World Forum for Harmonization of Vehicle Regulations

Proposal for Supplement 8 to the 03 series of amendments to UN Regulation No. 129 (Enhanced Child Restraint systems)

Submitted by the Working Party on Passive Safety *

Figure 1
Measurement Device to Check the Sitting Height

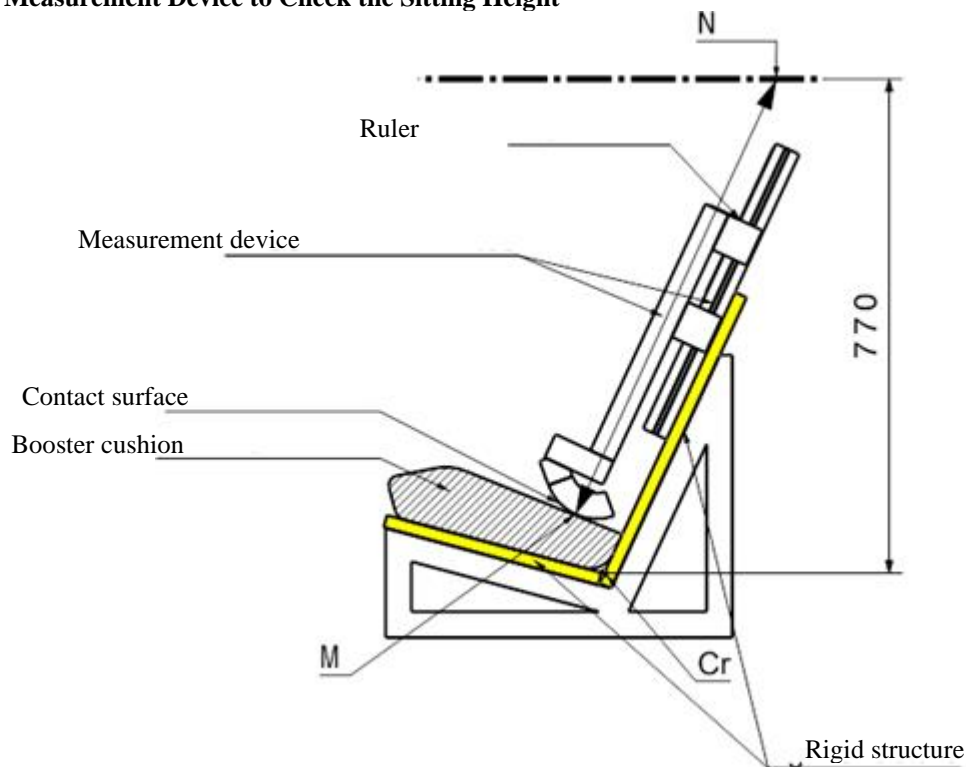
Paragraph 6.1.3.6., amend to read:

"6.1.3.6. For booster cushions, type approval shall not be granted for a stature below 125 cm. Booster cushions shall not be declared for use below a stature of 125 cm.

Booster cushions shall ensure that the top of the child's head is at or above a horizontal plane at 770 mm vertically from the Cr axis when seated on the test bench described in Annex 6.

The procedure to check if a booster cushion fulfils this requirement is outlined as follows (See figure 1 below):

- (e) The measurement device is extended downwards parallel to the simulated test bench backrest, until it is stopped by the booster seat cushion.

Figure 2
Ruler of Measurement Device

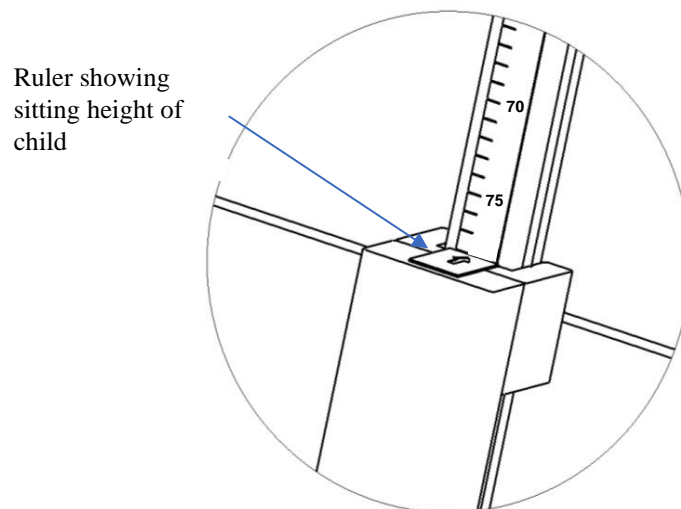
- (f) The corresponding value of the sitting height is displayed by a ruler that is provided with the device as shown in Figure 2.
- (g) Using the data in Table 3, the sitting height is utilized to determine the corresponding minimum stature of the child that can be accommodated by the booster cushion. Example: A sitting height of 66.2 cm shall correspond to a child minimum stature of 125 cm; a sitting height of 75.9 cm shall correspond to 150 cm.

In case the value obtained for the sitting height is between two integer values always round up to the next integer value (e.g. Measured sitting height = 70.1 cm ► resulting stature = 136.05 cm ► Smallest stature allowed = 137 cm).

Figure 1
Conditioning for adjusters mounted directly on Enhanced Child Restraint Systems

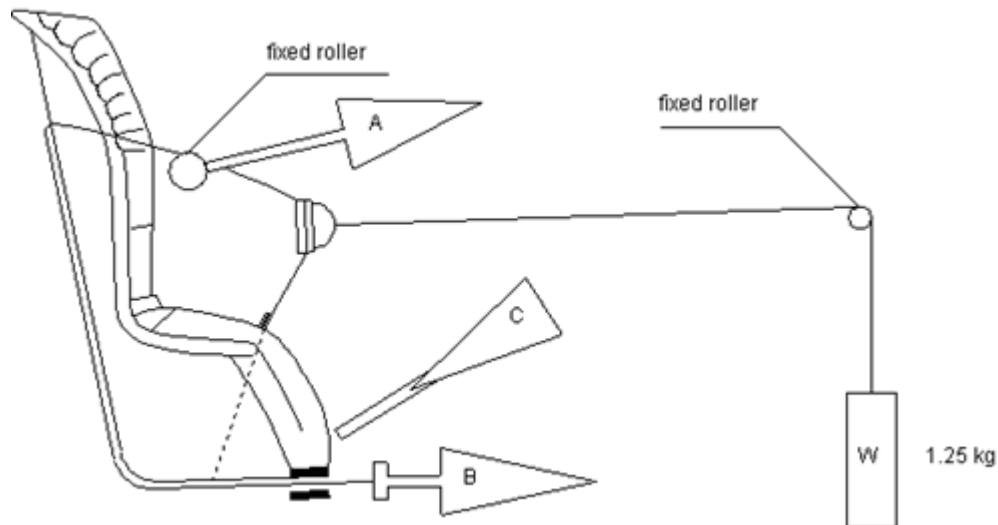
Annex 15, amend to read:

1. Conditioning for adjusters mounted directly on Enhanced Child Restraint Systems (Figure 1)
 - 1.1. Method
 - 1.1.1. With the webbing set at the reference position described in paragraph 7.2.6.1., withdraw at least 50 mm of webbing from the integral harness by pulling on the free end of the webbing.

- 1.1.2. Attach the adjusted part of the integral harness to the pulling device A.
 - 1.1.3. Activate the adjuster and pull at least 150 mm of webbing into the integral harness. This represents half of one cycle and puts pulling device A to the maximum webbing extraction position.

- 1.1.4. Connect free end of webbing to pulling device B.
 - 1.2. The procedure of the cycle is:
 - 1.2.1. Pull B at least 150 mm while A exerts no tension on the integral harness.

- 1.2.2. Activate the adjusters (C) and pull A while B exerts no tension on the free end of the webbing.
 - 1.2.3. At the end of stroke, de-activate the adjuster.

- 1.2.4. Repeat cycle as specified in paragraph 6.7.2.7. of this UN Regulation.

Figure 2
Conditioning for adjusters connected to a strap (not directly mounted on Enhanced Child Restraint Systems)

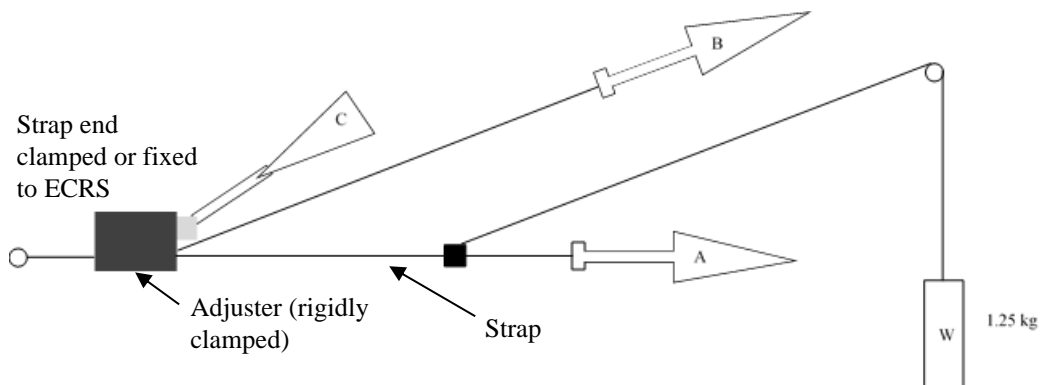
2. Conditioning for adjusters connected to a strap (not directly mounted on Enhanced Child Restraint Systems) (Figure 2)
 - 2.1. Method
 - 2.1.1. Rigidly clamp the adjuster

- 2.1.2. With the strap set at the reference position described in paragraph 7.2.6.2., withdraw at least 50 mm of strap from the adjuster by pulling on the free end of the strap.

- 2.1.3. Attach the adjuster part of the strap to the pulling device A.
 - 2.1.4. Activate the adjuster (C) and pull at least 150 mm of strap through the adjuster. This represents half of one cycle and puts pulling device A to the maximum strap extraction position.

- 2.1.5. Connect the free end of the strap to pulling device B.
 - 2.2. The cycle is:
 - 2.2.1. Pull B at least 150 mm while A does not exert tension on the strap.

- 2.2.2. Activate the adjuster (C) and pull A while B does not exert tension on the free end of the strap.
 - 2.2.3. At the end of the stroke, de-activate the adjuster.

- 2.2.4. Repeat the cycle as specified in paragraph 6.7.2.7. of this Regulation."

Device to measure the booster cushion height

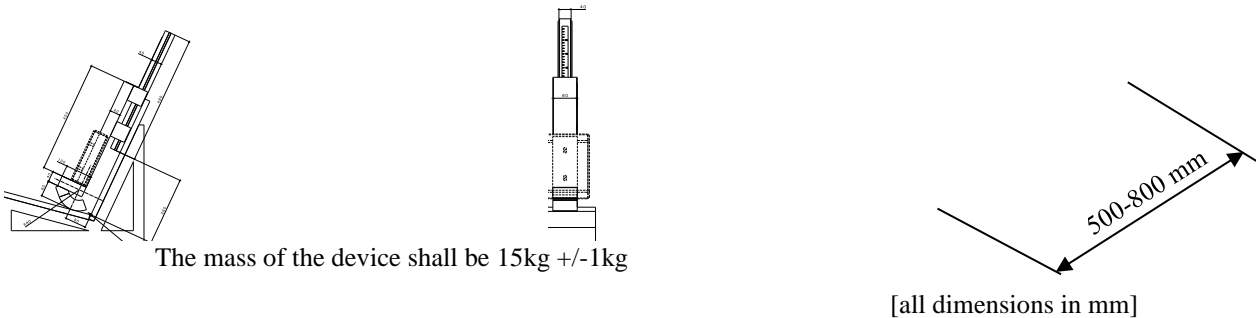
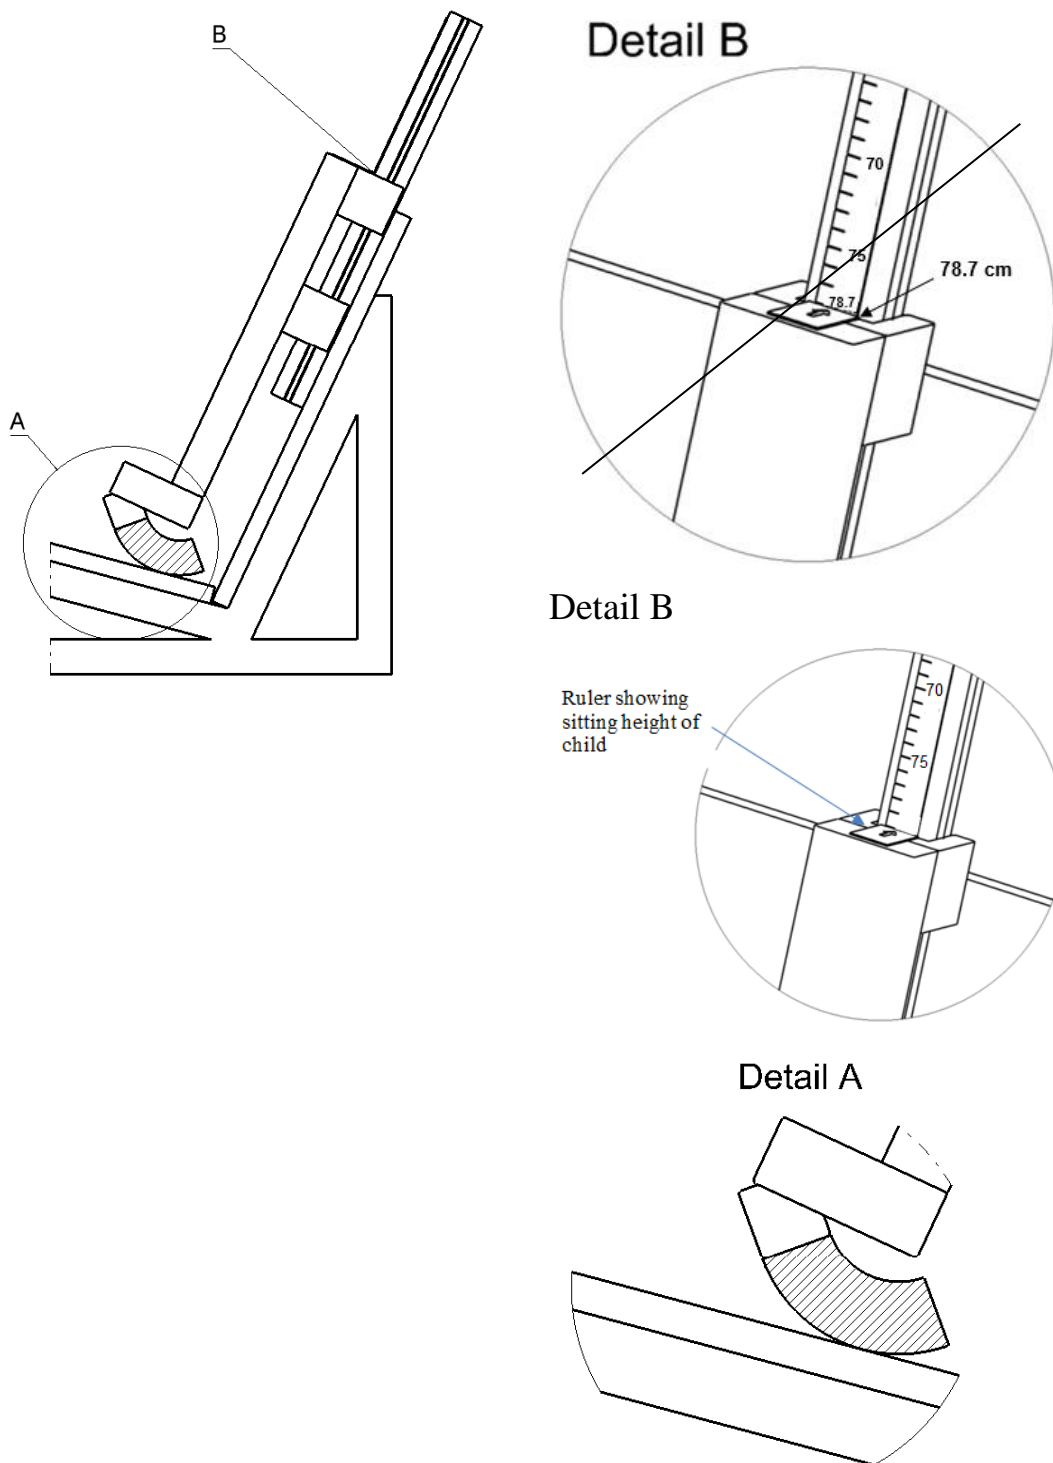
Annex 25., amend to read:

Calibration of the measurement scale

To calibrate the ruler of the measurement device, its structure shall contact the supporting surface (Detail A). In this configuration, the scale shall show the calibration value of 79.7 cm (Detail B).

The calibration of the ruler is based on the sitting height of the Hybrid III 5th percentile dummy seated on the test bench defined in Annex 6 of this Regulation. When this dummy is seated on the test bench, the top of the head is 77.0 cm from the Cr axis. The nominal sitting height of the dummy is 78.7 cm. Taking this value as a reference, when translating the value to the 80 mm distance from the test bench backrest where the sitting height of the child is measured, and taking into account the different angles in between the backrest, the horizontal plane and the head position, a value of 79.7 cm is used as the calibration value.
